SPECIAL USE REPORT

▶ **FILE #:** 7-H-26-SU

▶ **PROPOSED USE:** Expansion of a church

► **Approve the request for the expansion of a place of worship, subject to 4 conditions.**

SHEET INFORMATION
A201
EXTERIOR ELEVATIONS

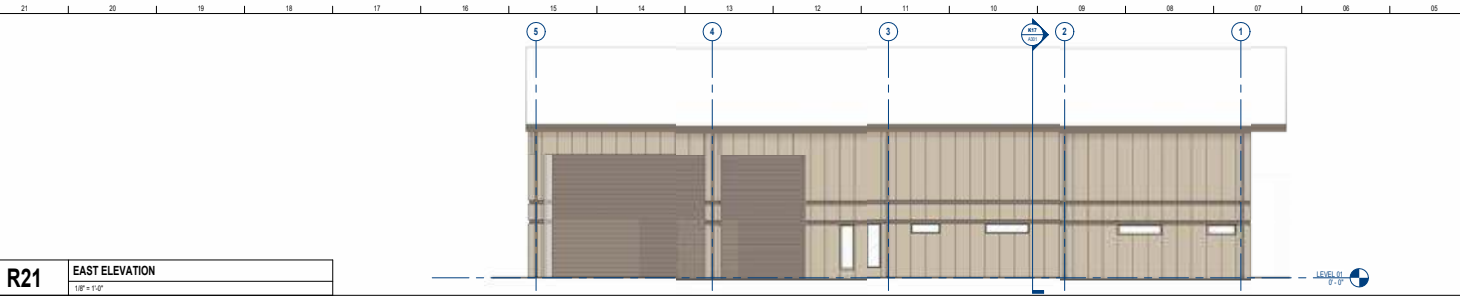
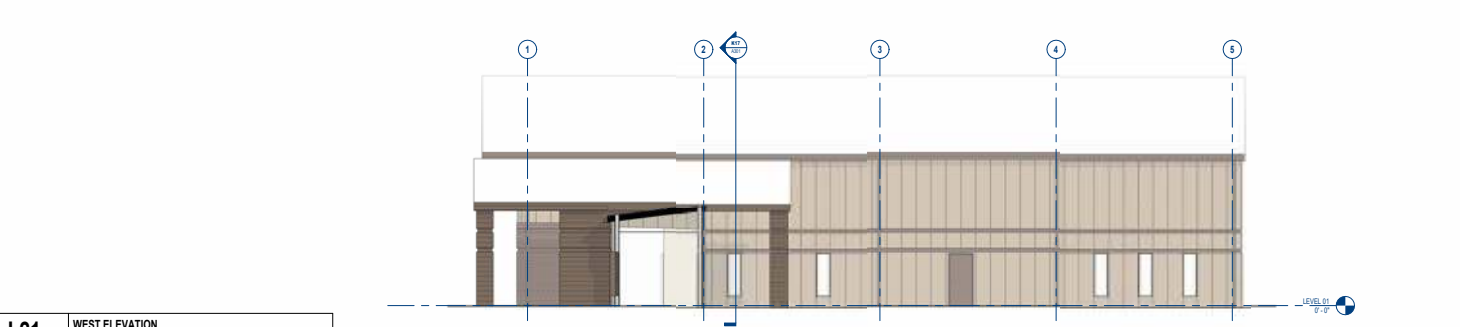
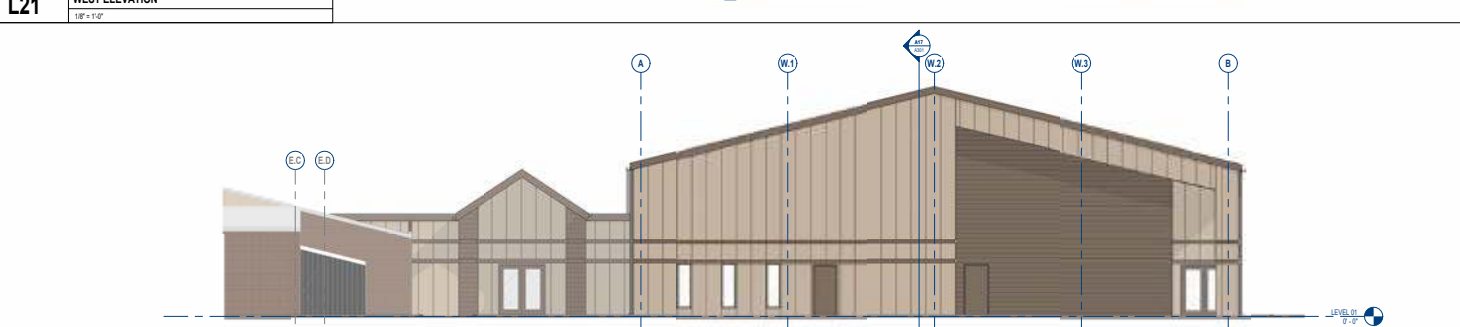
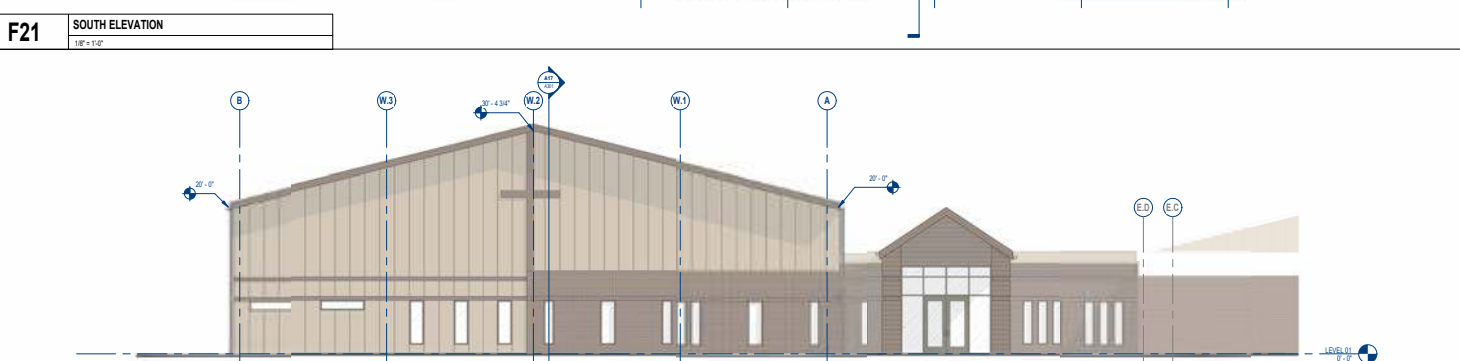
A. The church has operated at this location since the 1980s, and the proposed addition is consistent with the character of this segment of Beaman Lake Road, which features multifamily developments on the same side as the church and single-family dwellings across the street. The proposed 31.35-ft height is compatible with the 1-3-story heights of existing residential structures nearby and with the 4-story multifamily building under construction to the south.

L101
SPECIAL USE
LANDSCAPE PLAN

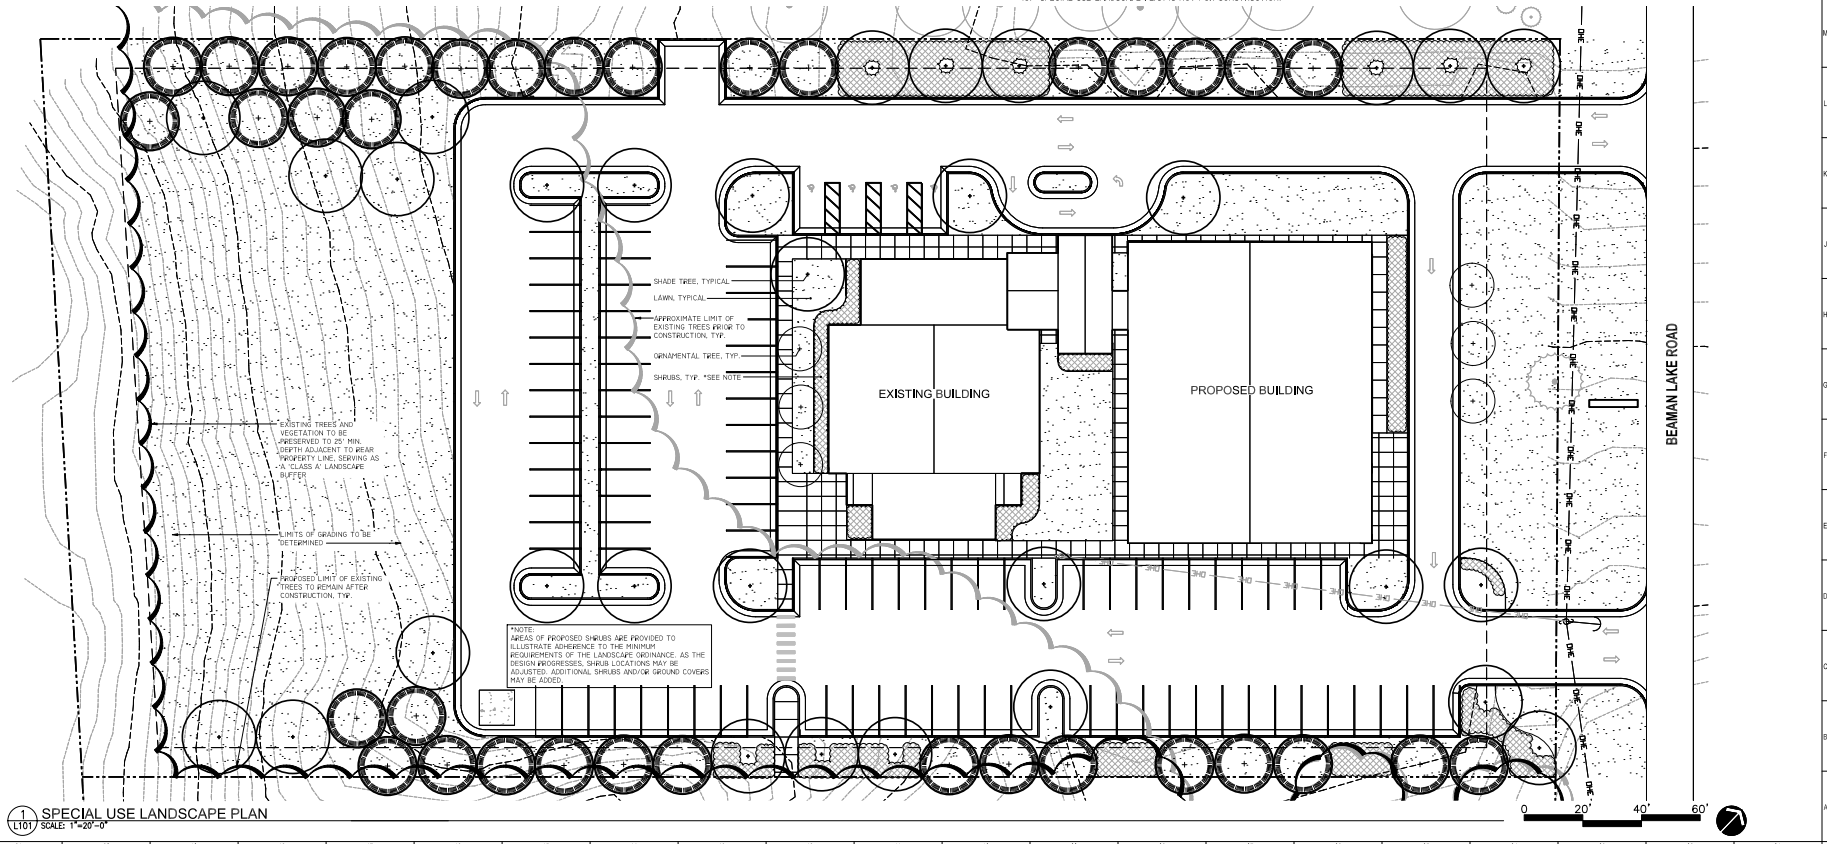
- C. The proposed landscaping is designed under the current zoning ordinance standards (Article 12), which exceeds the requirements of the former zoning ordinance (Article V, Section 7.A.5). Per condition 1, the City's Urban Forestry division will review the landscaping requirements under the current standards during the permitting phase.

A. The proposed expansion is not expected to have any significant adverse impacts on adjacent properties. Landscaping is proposed along the property's northern and southern boundaries, which abut multifamily developments. The proposed landscaping across the site and the removal of the gravel parking lot from the front yard would improve the property's aesthetics.

1. Meeting all applicable requirements of Article 12 (Landscape) and any requirements of the City of Knoxville Urban Forestry Division during permitting, and installing the landscaping as shown on the landscape plan. Tree species may be changed to meet the species diversity requirement (Article 12.4), but the number and general location of plants shall align with the proposed landscape plan.
2. Meeting all applicable requirements of the City of Knoxville Zoning Ordinance.
3. Meeting all applicable requirements of the City of Knoxville Department of Plans Review and Inspections.
4. Meeting all applicable requirements of the City of Knoxville Department of Engineering.
